Item ID: D205-596-103B Accept *N900040100* Setup Start *NS1*
 Revision ID: Stop *NS2*
 Item Name: Aft Crosstube - Extended Height 39"
 Start Date: 3/2/2015 Start Qty: 1.00 *1* Cust Item ID:
 Required Date: 3/2/2015 Req'd Qty: 1.00 *1* Customer:
 Reference:

Work Order: <u>130249</u> Part No. <u>D205-596-103B</u> NCR No. <u>15-4640</u>	DISPOSITION Rework ☐ Scrap ☐ Use-as-is ☒ Suspected Unapproved ☐	AGAINST DEPARTMENT/PROCESS

DRAWING NO. D205-596-103	TITLE CROSSTUBE ASS'Y, HI-HI AFT	REV. B	DART AEROSPACE LTD ENGINEERING ORDER		D.E.O. NO. D205-596-103-B-2	SHEET NO. SHEET 1 OF 1	SCALE NTS
DRAWN <i>qp</i>	CHECKED <i>A.P.</i>	MFG. APPR. <i>AA</i>	APPROVED <i>[Signature]</i>		DE APPR. <i>[Signature]</i>		
DATE 13.11.11	DATE 12.11.14	DATE 13.11.14	DATE 13/11/21		DATE 13/11/21

DRAWING NO. D205-596-103	TITLE CROSSTUBE	REV. B	DART AEROSPACE LTD ENGINEERING ORDER		D.E.O. NO. D205-596-103-B-3	SHEET NO. SHEET 1 OF 1	SCALE NTS
DRAWN <i>q</i>	CHECKED <i>A.P.</i>	MFG. APPR. <i>M</i>	APPROVED <i>q</i>		DE APPR. <i>q</i>		
DATE 15.01.15	DATE 15.01.20	DATE 15.01.20	DATE 15.01.20		DATE 15.01.20

FIGURE 1 - SUPPORT INSTALLATION

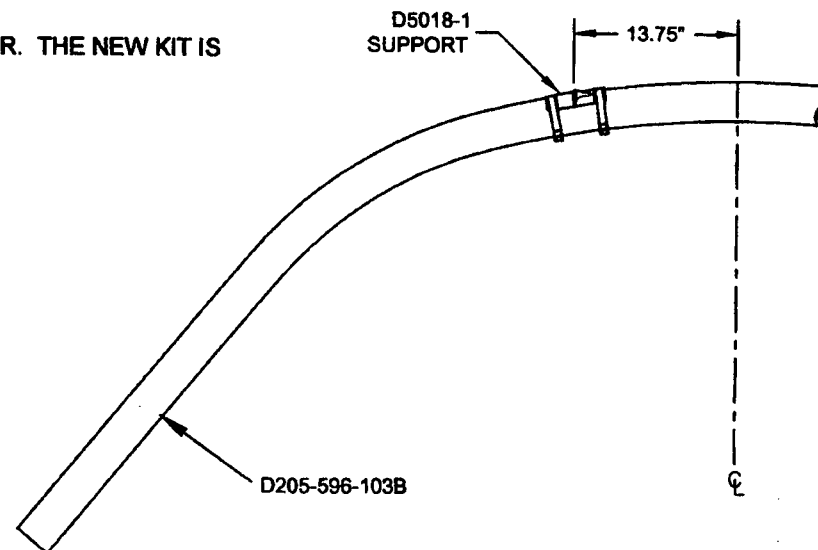
ADD THE FOLLOWING CROSSTUBE ASSEMBLY:

Qty	Part Number	Description
X	D205-596-103B	CROSSTUBE ASSEMBLY (214 HI-HI AFT)

THE D205-596-103B CROSSTUBE HAS THE SAME PARTS LIST AS THE D205-596-103 CROSSTUBE EXCEPT AS FOLLOWS:

IS:

2	D5018-1	SUPPORT
---	---------	---------

WAS:

2	D2940-1	SUPPORT
---	---------	---------

INSTALL THE SUPPORTS AS SHOWN IN FIGURE 1 OF THIS ENGINEERING ORDER. THE NEW KIT IS OTHERWISE ASSEMBLED PER THE D205-596-103 CROSSTUBE.
